MEMO

Re: 3rd Review for new construction at 156 S HIGH STREET
(Note: 158 S High Street's 3rd review was dated September 18, 2019)

An example of a simple building plan diagram.

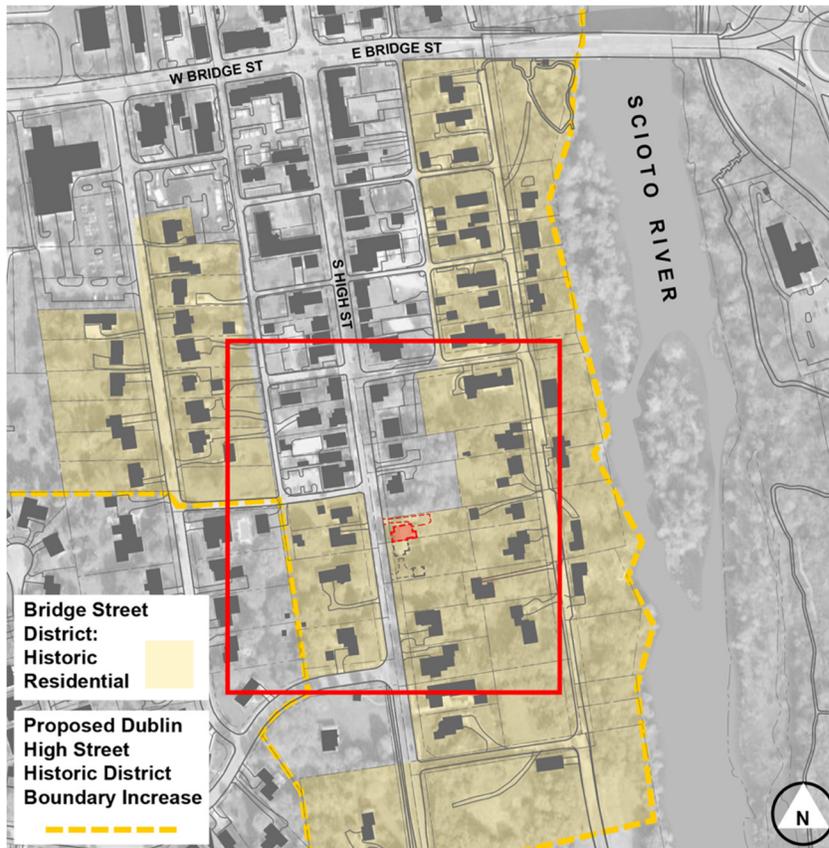
In terms of lot coverage in comparison with nearby properties, the proposed footprint is similar to nearby houses. But unlike nearby properties, the general shape of the building shows multiple crenulations in both plan and elevation that are not characteristic of the neighborhood's fabric and are therefore not desirable for a new build in this location. Most houses in the immediate area are originally of a vernacular form: a one-and-a-half Gabled Ell or a Cape Cod Cottage (see Photos along High Street at the end of this report). It is recommended to take massing cues from nearby buildings. With the narrow lot width, it is recommended that the designer revise the building's mass. A diagrammatic approach could help direct the design. For example, there could be three masses, with the mass closest to the street matching the original building width at 182 S. High, and the mass furthest east consisting of a single-story garage. The massing could be as simple as this diagram where the red rectangle represents a one-and-a-half front-gabled stone masonry mass, and the

green rectangle could be a single-story garage with its roof used as a patio, and the blue is a two-story hyphen/connector.
